**PLANNING PERMIT P22/3046  
5 PALM GROVE DROMANA VIC 3936  
ENGINEERING APPROVAL WITH APPROVED PLANS**

I advise the plans No. JDSS3222 Drawing C1 and C2 Revision B for drainage connection into the existing underground system within Dalworth Avenue, drainage detention within the site, vehicle crossing/s and internal driveway on the above project are in general accordance with conditions of the planning permit and are approved, **subject to notes in red on approved plans.**

PROPOSED DRAINAGE FOR A PROPOSED DWELLING AT  
**No. 5 PALM GROVE DROMANA**  
(MELWAY REF: 160, A6)

DRAWING NO. JDSS3222-C1

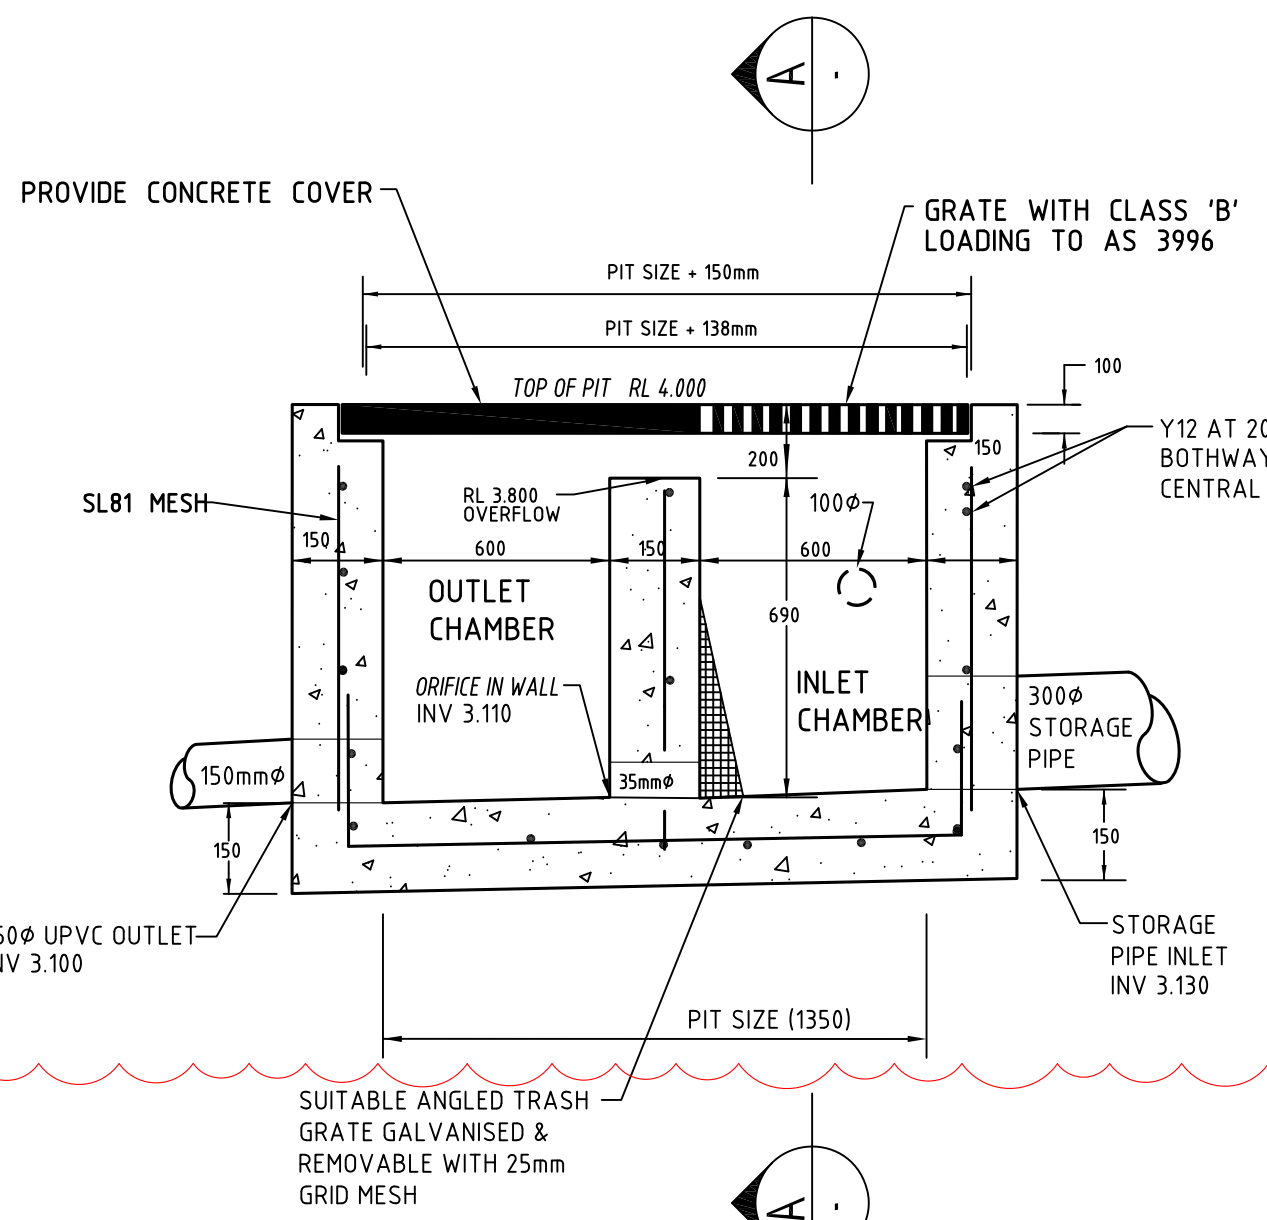
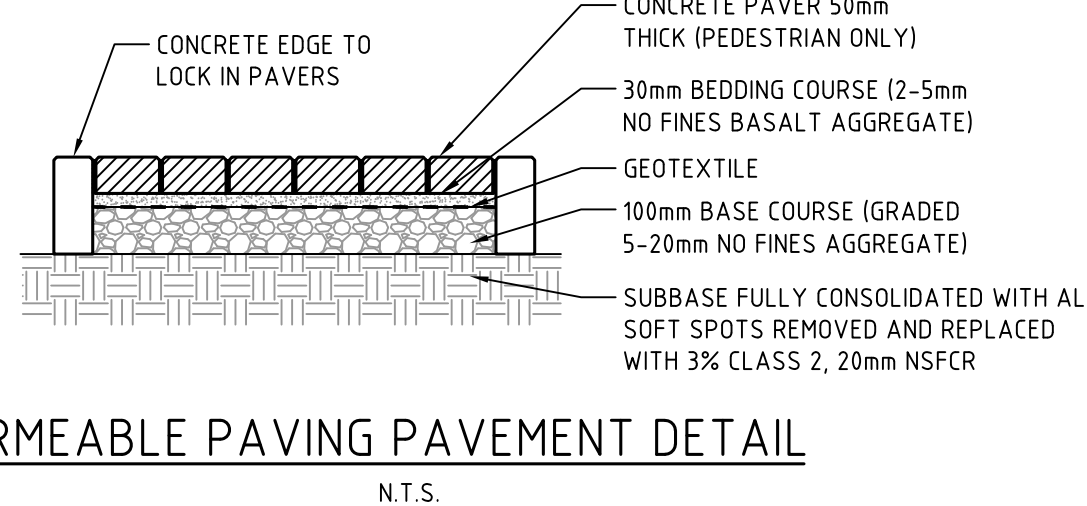
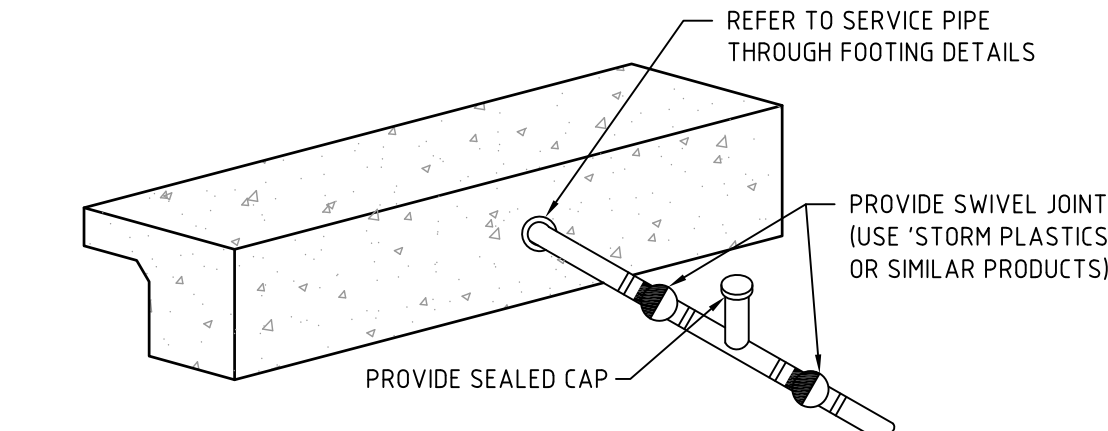
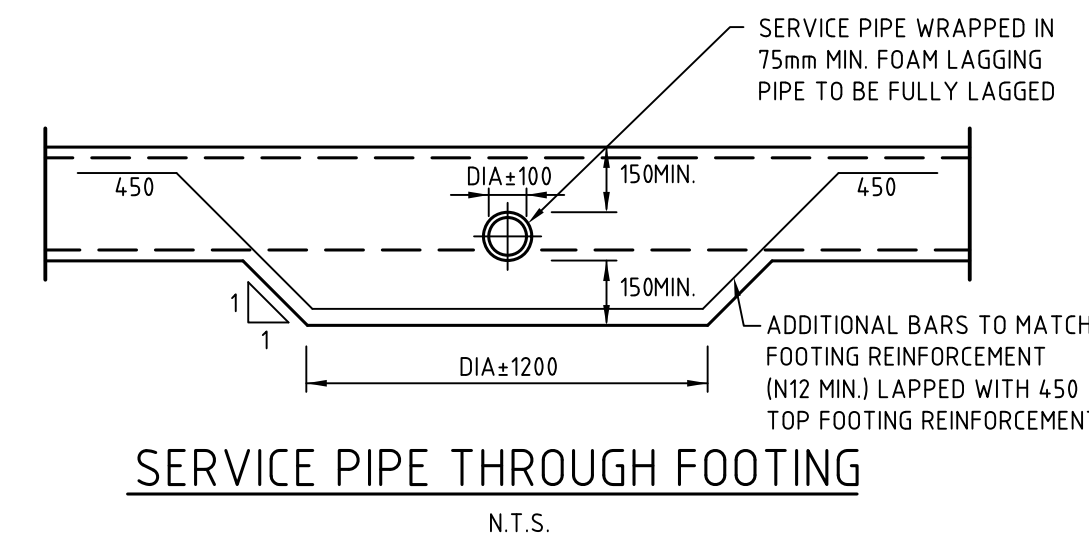
ALL WORKS TO BE CARRIED OUT IN ACCORDANCE WITH THE CURRENT MORNINGTON PENINSULA SHIRE SPECIFICATIONS AND STANDARD DRAWINGS AND TO THE SATISFACTION OF THE CONSTRUCTION AND ASSET PROTECTION TEAM

A CONSTRUCTION MANAGEMENT PLAN (CMP) MUST BE SUBMITTED TO, AND APPROVED BY COUNCIL 15 BUSINESS DAYS PRIOR TO THE COMMENCEMENT OF ANY WORKS ON SITE AND ALL WORKS MUST BE CARRIED OUT IN ACCORDANCE WITH THIS CMP

Any redundant pop holes to be reinstated to the satisfaction of the Responsible Authority

A ROAD OPENING / DRAINAGE CONNECTION PERMIT must be obtained for any works external to the site or within an easement.  
A COUNCIL INSPECTION must be arranged PRIOR TO THE COMMENCEMENT OF WORKS by contacting the Asset Protection Team on (03) 9550 1040.

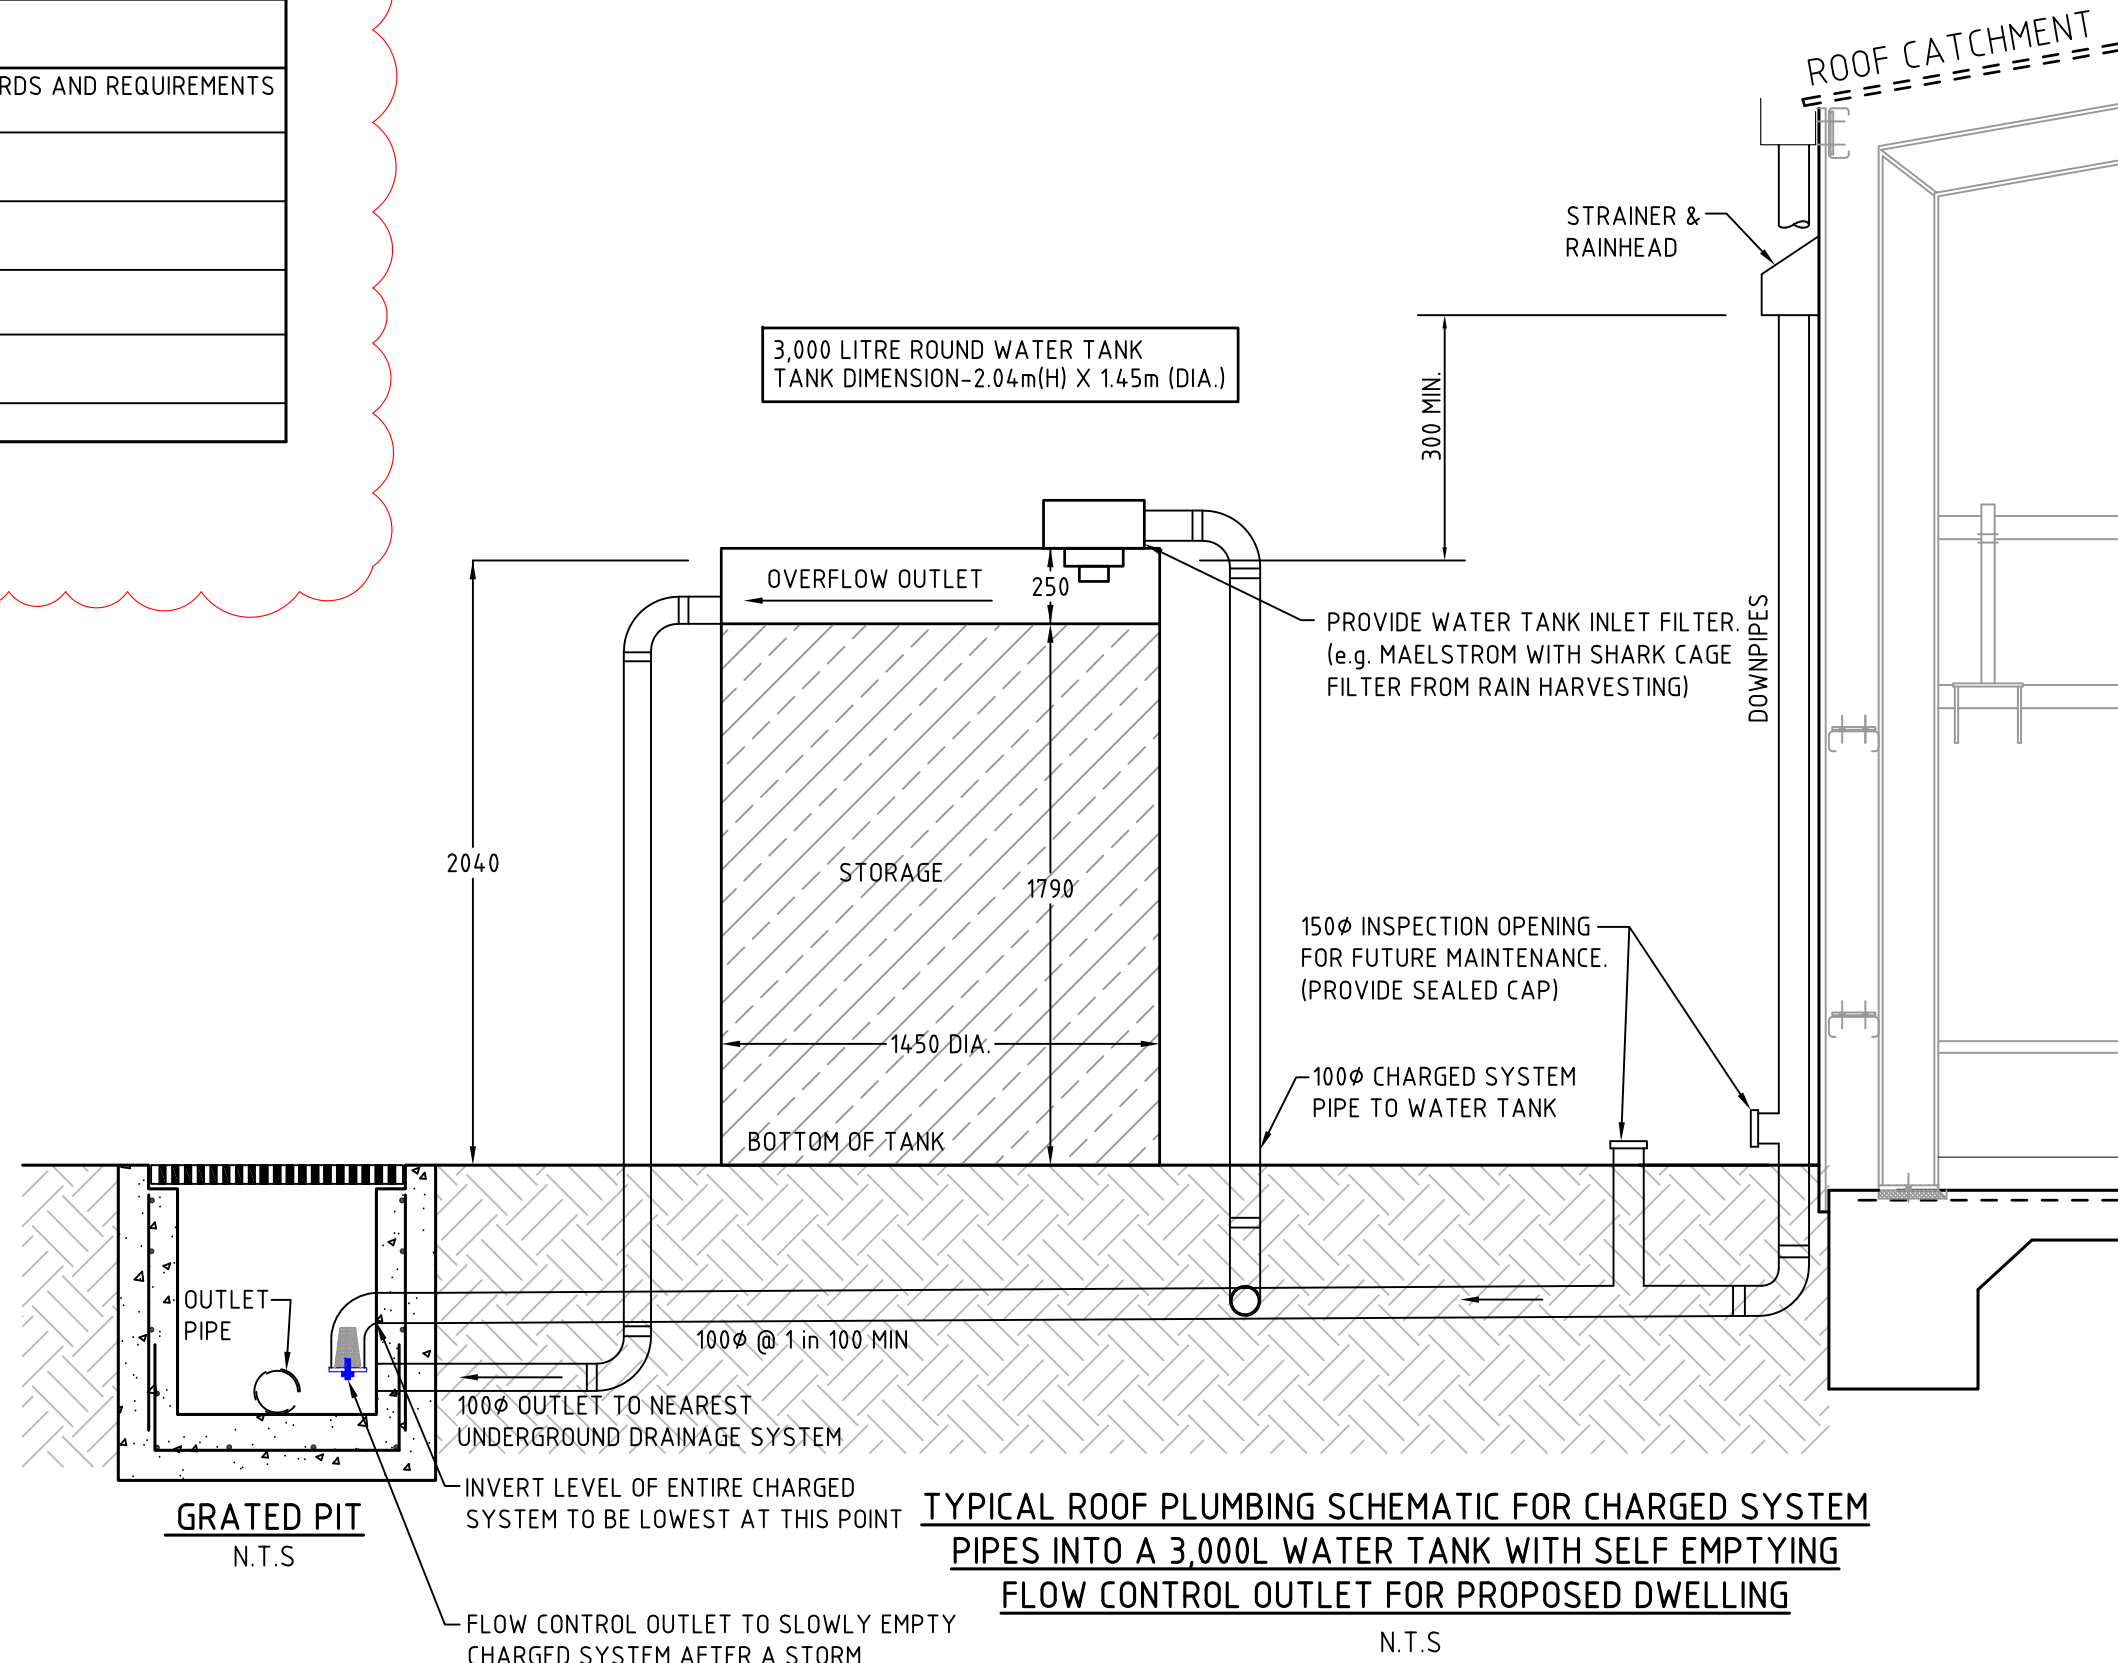
Mornington Peninsula Shire hereby approves this engineering plan for driveway and stormwater drainage works pursuant to the provisions of the Planning and Environment Act 1987 and the Subdivisions Act 1988.

Note: The relevant Building Surveyor is responsible for the approval of the design and inspection of stormwater drainage system prior to the issue of a Certificate of Occupancy, as required by building regulations. Any assets to be taken over or maintained by the Shire must comply with the Shire's relevant standards.

Date: 30/05/2024  
Planning permit No(s): P22/3046  
Eng No: ENG23/0014  
Applies to Sheets: C1 - C2  
Development Engineer: Bhupinder Gill
